AGENDA
La Vergne Planning Commission
June 27, 2023 at 6:00 PM

MINUTES OF THE REGULAR MEETING OF THE CITY OF LA VERGNE PLANNING COMMISSION HELD ON MAY 30, 2023 AT LA VERGNE CITY HALL, LA VERGNE, TENNESSEE.

SITE UTILITY
PLAN

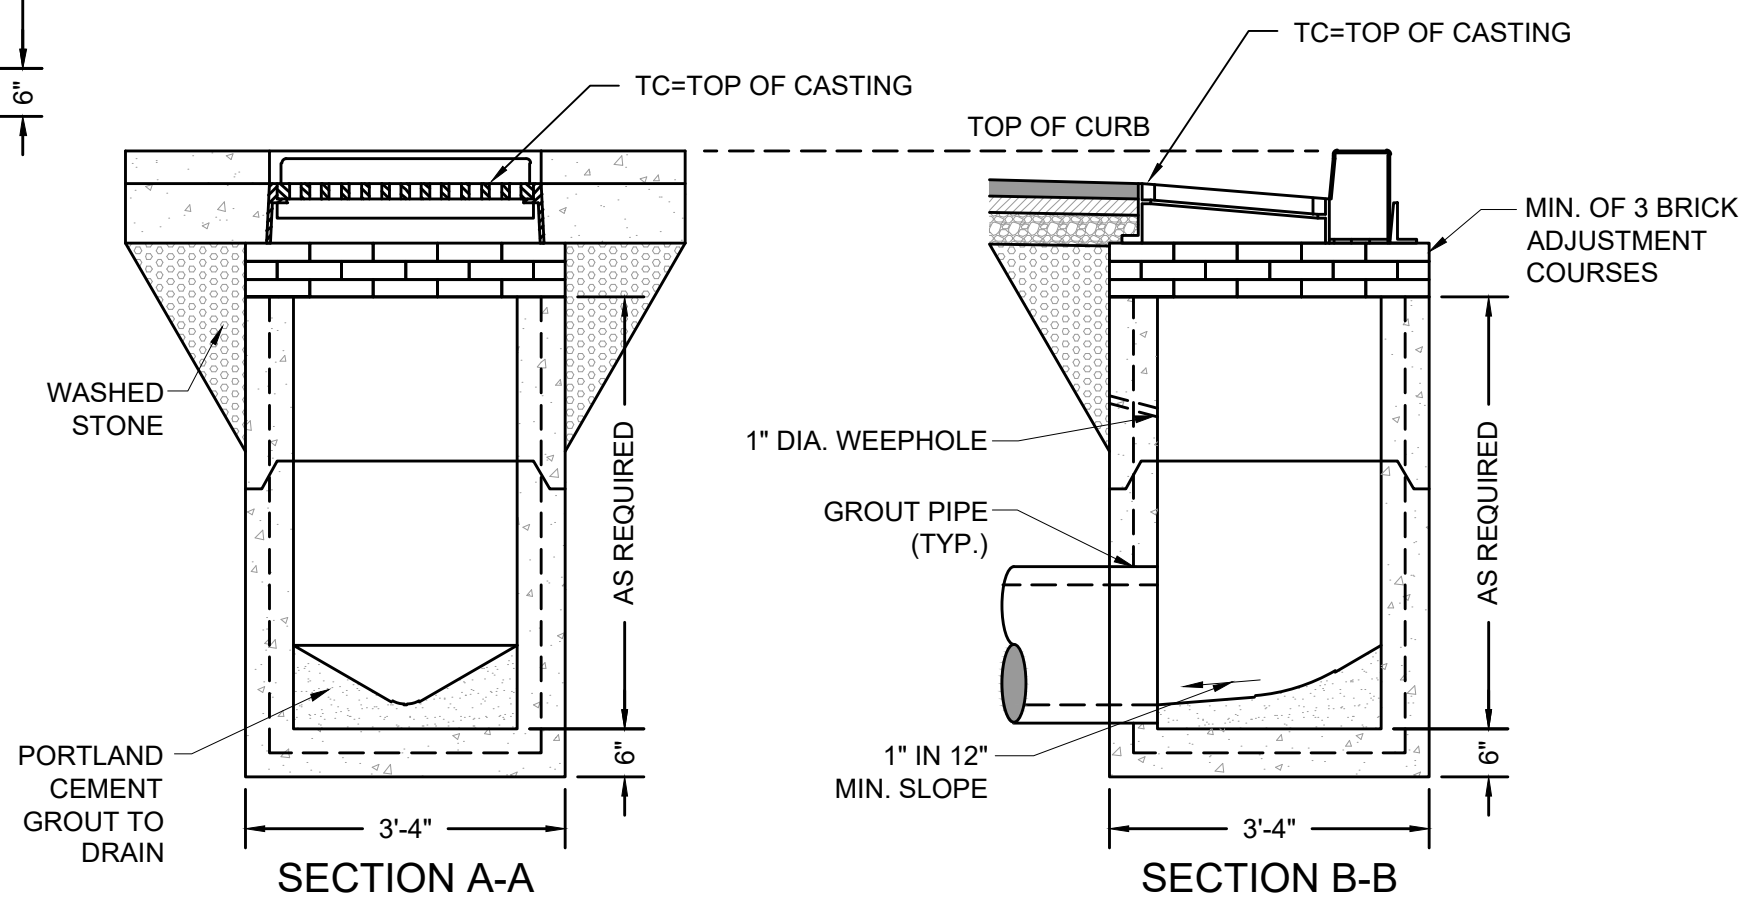
9. (Sheet C3.0) Add note that no more than 500' of utility trench may be open at one time.
 10. (Sheet C1.0) If a dumpster is needed for this building, provide location and pad/enclosure details.
